Comments on Revised Noise Impact Study

*Re: Independent Peer Review of the Revised Noise Impact Study for the
Saddleback Ridge Wind Project*

Re: *Remand for Saddleback Ridge Wind, LLC, L-25137-24-A-
N/L-25137-TG-B-H (Approval)- Comments of Appellants
Friends of Maine's Mountains et al. on Revised Noise Report*

Subject: Comments on the Peer Review by Peter Guldberg of Tech Environmental
 Saddleback Ridge Wind Farm, Carthage, Maine. RSG, Inc. Revised April 2013

Figure 1-Interturbine spacing using SWR report Figure 18: Modeled Sound Pressure Levels (dBA) under Normal Operating Conditions

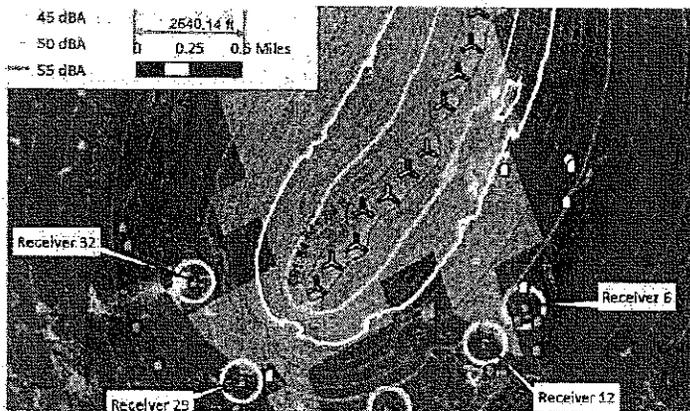
It is generally accepted by acousticians working with wind turbines that to avoid having the wake and associated turbulence produced by one turbine become the inflow air for turbine(s) located downwind that a separation distance between turbines of at least 5 rotor diameters is required. For a wind turbine with a 103 meter blade five (5) rotor diameters is approximately 1,690 feet. Three (3) rotor diameters is 1014 feet. Inspection of the figures showing the location of the wind turbines on Saddleback Ridge finds that the turbines are closely spaced with inter-turbine spacing of less than 5 rotor diameters being a frequent occurrence. In some cases, the separation distance may be as little as 700 feet, less than three (3) rotor diameters.

The RSG report acknowledges the need to maintain separation distances in its discussion at 10.1 Causes of amplitude modulation. That section states that to avoid amplitude modulation turbulence must be avoided. RSG notes that turbulence may be naturally occurring or created by wakes from upwind turbines. Again on page 25 the report states: *"Inflow turbulence between turbines in a turbine string can also affect noise from the wind farm. Proper turbine siting and operation minimizes this type of turbine wake impact."* No mention is made of the close inter-turbine spacing for this project and no adjustments are

Response: The appellants say that "it is generally accepted by acousticians working with wind turbines that to avoid having the wake and associated turbulence produced by one turbine become the inflow air for turbine(s) located downwind, that a separation distance between turbines of at least 5 rotor diameters is required." No support is given for this assertion. Acousticians generally have no expertise in calculating the level of turbulence created by a wind turbine. A similar claim was made in testimony submitted by Mr. James in the Saddleback Ridge Wind DEP permitting proceeding, and at that time he cited a teleconference with "GE management in charge of land and offshore wind turbines."¹ We know of no rule-of-thumb with respect to turbine spacing and turbulence. Turbine spacing at SRW is based on site-specific topography, meteorology and other factors, and was developed based on the expertise of the

Figure 19: Wind profile power law exponent by time of day for 90 meter predicted wind speeds above 4 m/s. Boxes show 90% of data and "whiskers" are the +5% and -5% outliers

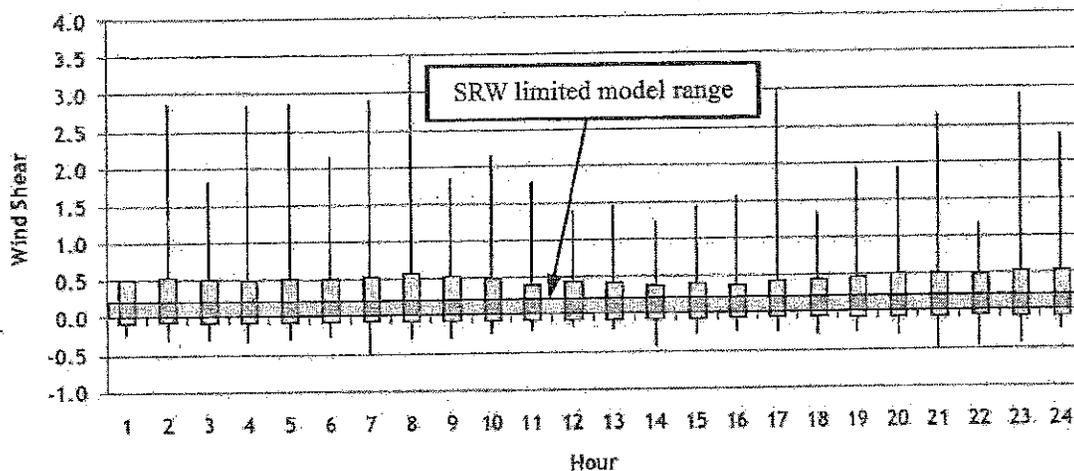
accordance with the IEC 61400-11 standard with high wind shear. The Noise Report failed to do this. IEC 61400-11 specifies neutral wind profile conditions, that is, low wind shear (roughness length of 0.05 m, e.g. shear < 0.2). GE's standard practice is to quote maximum sound power output for low wind shear, e.g. "logarithmic wind profile for surface roughness (z_0, ref) = 0.03 m". This is a *low* wind shear condition, consistent with IEC 61400-11, NOT a high wind shear condition required by the DEP. To make the point more clearly, GE *offers* to supply maximum sound power output under high shear conditions, if requested.

The Noise Report figure below shows the wind shears that would be encountered at the site. The figure marks in red the very narrow range of operating wind shear within which, sound levels are guaranteed (0-0.2). It is clear that most of the time, the wind turbines would be operating *outside* guaranteed operating conditions. The Noise Report authors *did not request these data from GE and did not submit* the sound data for those "worst-case" conditions. Therefore it is deficient as a matter of law.

Response: International Standard IEC 64100-11 does not limit test conditions to low shear conditions. Appellants are misinterpreting the "reference roughness length" of 0.05 m, which is used after field measurements are collected to adjust the data to "reference conditions" (Section 8, Equation 7). Section 7.2.1 of the IEC Standard lists acoustic measurement requirements and directs that measurements be taken to cover as broad a range of wind speeds as possible. By

Figure 1. Comparison of Model and Measured Far Field Noise Levels: Mars Hill: 28 GE1.5sle Wind Turbines, and Stetson: 38 GE1.5sle Wind Turbines. The downwind data are similar for both facilities, supporting a minimum 5 dB uncertainty adjustment is needed for modeling from sound power levels.

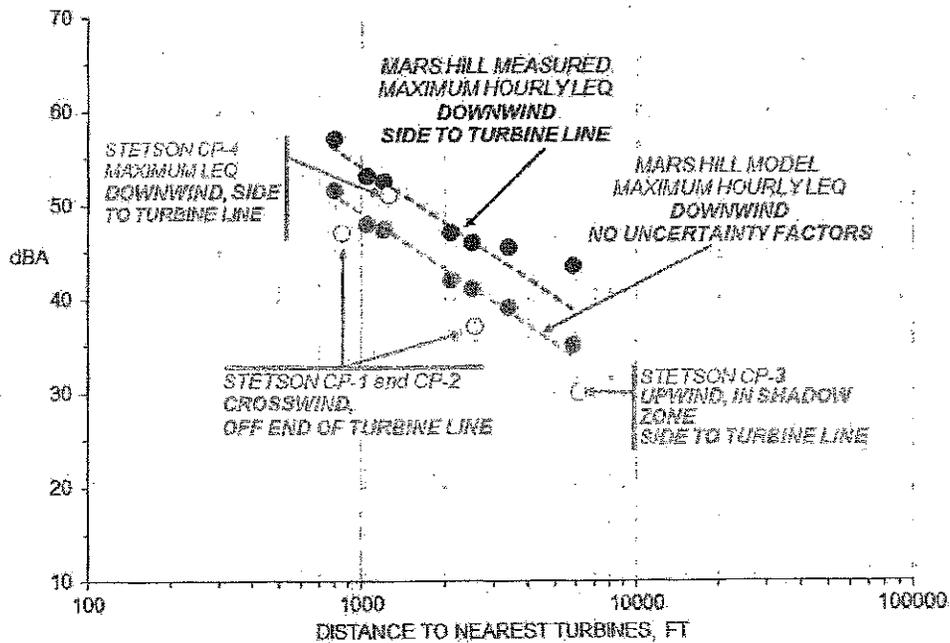
Wisconsin and other wind turbine sites. Large industrial wind turbines "worst case" sound levels are consistently 5-8 dB louder than predicted from manufacturer's "typical" sound power levels. One year of Mars Hill sound measurements determined facility sound levels [1] were 5 dB higher than the model predicted and at times as high as 7-8 dB.

Careful review of the field data underlying the DEP routine rulemakings indicates that the full 5 dB uncertainty adjustment is warranted and appropriate. After the 2008 year-long study at Mars Hill, the DEP considered it necessary to apply a minimum of 5 dB for the uncertainty adjustment for future wind project applications. Recently, this was inappropriately decreased to 0-2 dBA for mountain locations based on a flawed analysis of wind turbine measurements at Stetson [2]. A careful review of the limited Stetson

downwind data (see CP-4 in Figure 1 below) determined that the Stetson facility has the potential for the same 5-dB noise increases over the basic noise prediction model as used for Mars Hill (same turbines).

The appellants present their own chart of monitoring data from Mars Hill. However, this data was not collected using the current protocol outlined in Chapter 375(10)(I)(e), nor was it analyzed for compliance using the current methodology. The same Mars Hill monitoring results were presented to DEP by Ambrose & Rand in a report dated December 9, 2010 in opposition to the Saddleback Ridge Wind project, on their Figure A.3-1, which is part of the record of this permitting proceeding. Between then and now, the compliance assessment methodology has changed, including the change from evaluating the highest 10-minute Leq to an arithmetic average of 12 10-minute Leqs, but their evaluation of the Mars Hill monitoring results remains

Response: As noted above, the Mars Hill monitoring data is not collected nor evaluated according to the current DEP methodology, which includes a higher level of quality control, techniques to control for background noise, different SDRS and tonal methods; and different averaging times and methods. More recent monitoring done consistent with the current methodology shows that the approach used in the Saddleback Ridge noise assessment is conservative and consistent with the allowable range of values given by the DEP Chapter 375(10)(I) regulation.

Figure 2. Comparison of SRW 2013 Model, and measured levels at Mars Hill (quieter, lower-power turbines).

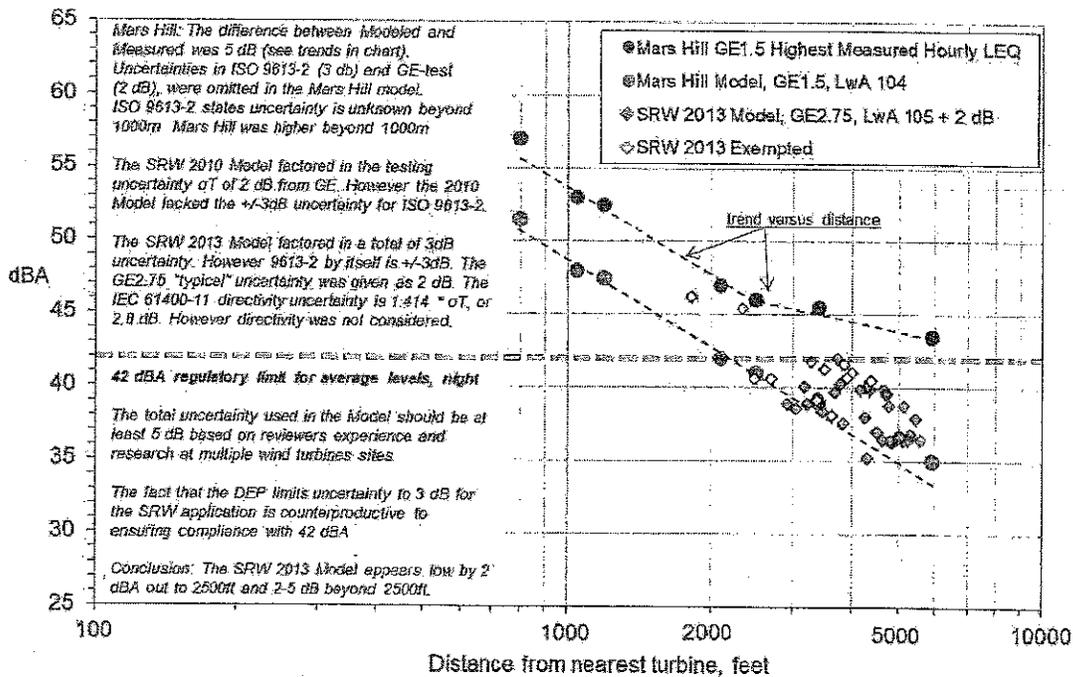
Based on our experience, the 7-8 dBA difference measured at Mars Hill beyond 2500-ft is representative and probable for homes near the SRW (see Figure 2). However, it is apparent that an additional 2-3 dB safety margin above the 5 dB uncertainty would have been prudent to ensure compliance with the Supreme Court order. Given the small track record in Maine for large facilities, the Noise Report has too little consideration for including prediction model safety factors. **The DEP should exercise its discretion under 10(E) and require 5 dB total uncertainty to assure compliance.**

The peer-reviewers find that the RSG model is too low by at least 2 dB compared to actual field-measurements showing at least a 5-dB difference between model and measured levels for ridge-top wind turbines in Maine. The Noise Report's modeled sound levels are provided in Table 1 below, which includes a column presenting the computed total with a 5-dB uncertainty. It was found that two non-participating locations could exceed 42 dBA and another seven are within 1/2 dB of 42 dBA. Since sound meter variability are at least +/-1 dB, it may be assumed that these locations could be found to exceed the 42 dBA limit when measured in the field. When sustained SDRS penalties are assessed in accordance with the DEP routine rulemaking, all nearby locations are above 42 dBA.

Response: The appellants make an argument that the modeling conducted by the applicant is not consistent with their measurement of attenuation from a completely different wind farm, Mars Hill. The Mars Hill project has more than twice as many turbines and tighter turbine spacing. While the appellants' approach is novel, it is an "apples to oranges" comparison and not consistent with the requirements of Chapter 375(10), which require site-specific parameters when preparing predictive modeling estimates of sound levels.

Figure 3. Reaction level and percentage of people annoyed by wind turbine noise in rural areas, with SRW predicted noise levels. Actual noise levels are expected to be higher than predicted.

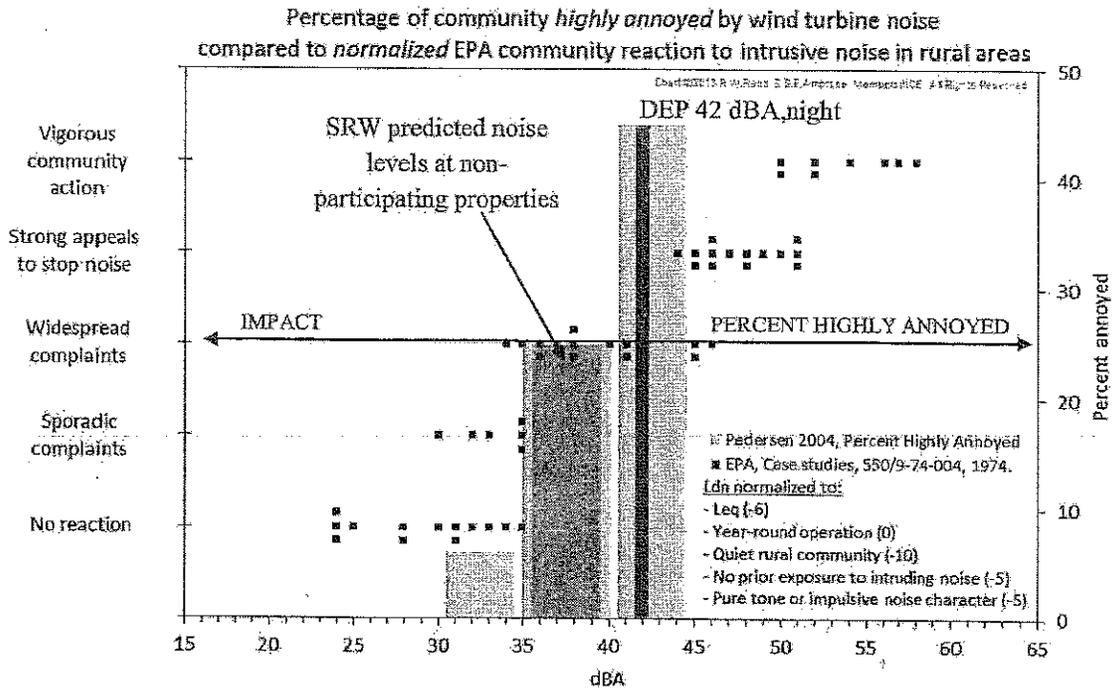
The authors developed a chart (see Figure 3) for simple review of potential community noise impacts *using the same Normalized CNR Method employed by other acoustical consultants*. Noise levels were also compared to well-known wind turbine noise annoyance findings [7]. Noise impact was determined for predicted SRW noise levels of 35 to 40 dBA at nearest non-participating residences (37 to 42 dBA when factoring in the 5-dB uncertainty found at Mars Hill). The result:

These deficiencies of the Noise Report call for additional conditions by the DEP using its discretion under Chapter 375.10.E to protect public health and welfare.

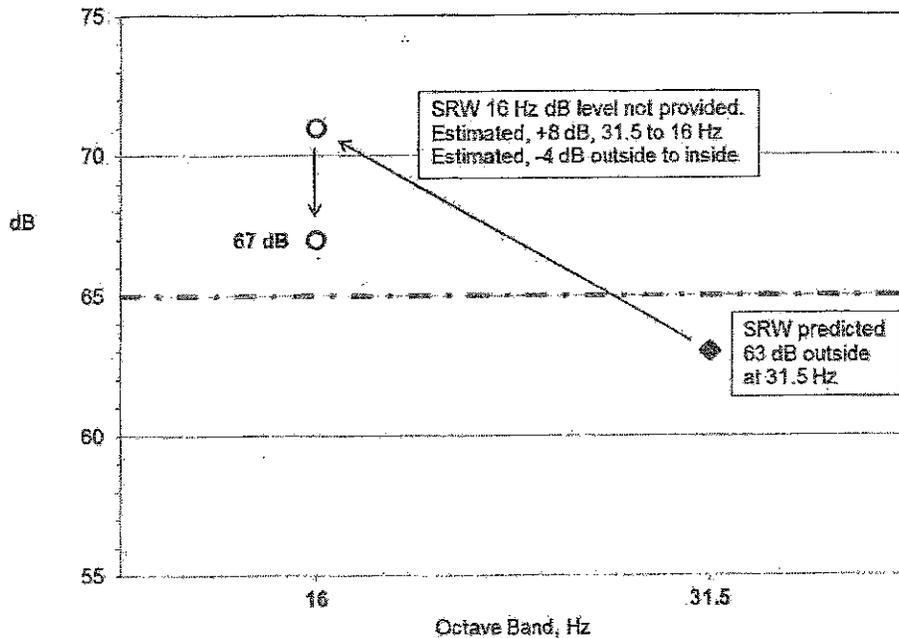
The Noise Report was deficient in not providing 16 Hz noise measurements for peer review to assess the statement. Despite carefully listing recommended noise limits to prevent vibration and rattles, the Noise Report did not bother to model low frequency sound at 16 Hz.

A comparative evaluation was done by the peer-reviewers using data [9] from Siemens 2.3-93 wind turbines, similar yet smaller and with shorter blades than the SRW turbines. In that reference's Figure 8.1-6b, the 16 Hz octave band sound level was documented at 8 dB higher than the 31.5 Hz band. In that reference's Section 8.3, the outside to inside noise reduction at 16 Hz was measured at 4-5 dB. The 16 Hz octave band interior noise level for residences near the SRW turbines was estimated assuming 1) the highest sound level outside at 31.5 Hz is 63 dB, 2) the difference between 16 and 31.5 Hz bands is comparable (+8 dB), and 3) the outdoor-indoor reduction is comparable (-4 dB conservatively, for windows open), using the equation shown below.

Response: The appellants' estimate of the worst-case participant 16 Hz sound level is speculation. First, there is no data available on the infrasound levels from the GE turbine that is proposed at Saddleback Ridge. There is no foundation to establish that the Siemens turbine measured in Texas has a similar spectral shape as the GE proposed at Saddleback Ridge. As an example, the difference between the 16 Hz and 31.5 Hz octave band sound levels cited by the appellants in Texas is 8 dB. In comparison, the difference between those two octave bands measured near the GE turbines at the Rollins project averaged 4 dB. Finally, the ISO 9613 methodology is not intended for estimating infrasound. While the subject of low-frequency sound is important, the Law Court did not remand the application to DEP for evaluation of low frequency noise, as low frequency noise is not regulated by DEP outside of its contribution to an overall A-weighted sound level.

Figure 3. Conceptual evaluation of differences in far-field dBA level due to differences in spectra shape. Although the GE 2.75 has a lower spectrum shape in the 200-800 Hz bands compared to the GE 1.5sle, there was no significant difference found in the dBA level in this example test.

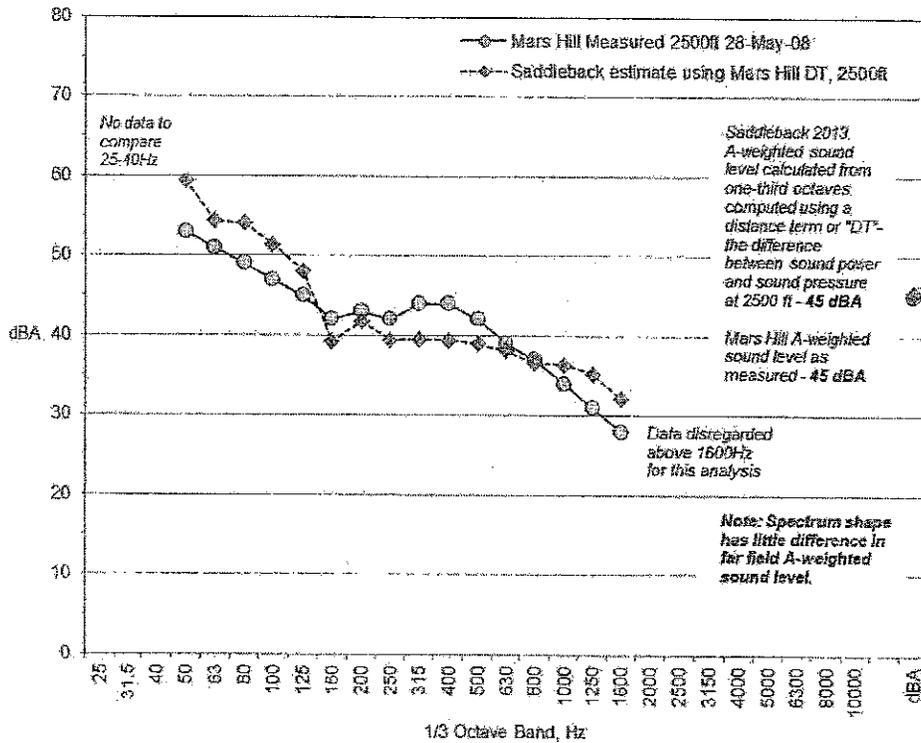
2.4. Contrary to the Noise Report's assurances, there is little evidence of increased far-field noise reduction for the revised GE 2.75 octave band spectra.

The Noise Report stated that the GE 2.75 MW wind turbines have "less sound energy in the lower frequencies and more sound energy in the higher frequencies. This has the effect of lowering sound levels at a distance, since higher frequency sound attenuates more quickly than low frequency sound." To evaluate this statement, the peer-reviewers obtained a real-world "distance term" (sound drop with distance) at Mars Hill where strong complaints and legal action surfaced. The model sound power level was compared to the measured sound pressure level for the distance of 2500 feet on May 28, 2008. The resulting distance term (DT: model minus measured) was applied to the SRW GE 2.75 sound power levels

to compute a sound pressure level spectrum and dBA value for 2500 feet [10]. The result is shown in Figure 3 above. This test is provided as an example of how to assess spectrum shape effects on dBA. However, contrary to RSG assurances, no significant reduction in dBA was found. It was inferred from this result that the Noise Report does not account for "worst case" propagation conditions found in the real world, which is a deficiency.

Figure A1.2-1. Fairhaven predicted levels and Mass DEP 2012 measurements (comparison by authors).

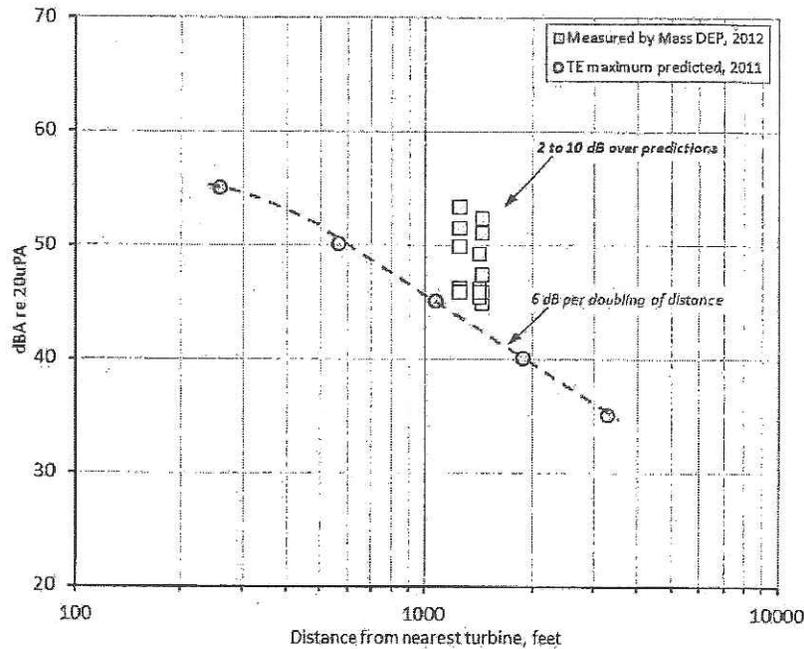
Guldberg/TE performed and certified the preconstruction noise study for two large 1.5-MW wind turbines in Fairhaven in 2011 and previously in 2007 [4]. It was stated in 2007 that the wind turbines would be inaudible to neighbors at least 40 percent of the time. No change was made to that statement in 2011. No review of noise levels, audibility or community noise impact was provided for similar sized 1.5-MW turbine noise impacts (Mars Hill, Freedom, and Vinalhaven, Maine; and many others).

Result: Strong complaints and appeals to stop the noise emerged soon after the turbine started operating. Following Massachusetts DEP field tests in 2012, the Guldberg/TE noise predictions were found to be 2-10 dB deficient (see Figure A1.2-1 below). The Mass DEP declared the facility out of compliance with State noise limits. The Fairhaven Board of Health has ordered the facility shut down at night until measures can be taken to reduce the noise levels.

Figure A1.3-1. Nantucket High School 100kw wind turbine predicted levels and field survey results, comparison from Advisory Letter, Attachment C (by authors).

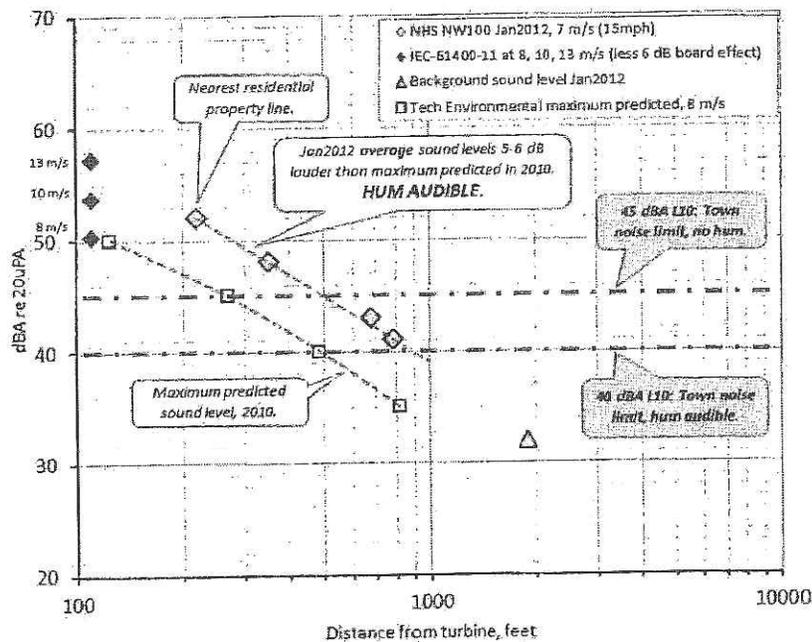
Result: Strong complaints and appeals to stop the noise emerged in the nearby residential area soon after the turbine started operating. The actual noise levels measured in 2012 were 5-6 dB higher than predicted and a prominent tone or hum was found [6]. Measurements indicated that the Town and the MADEP noise limits were exceeded respectively by up to 12 dBA and 20 dBA at the nearest properties.
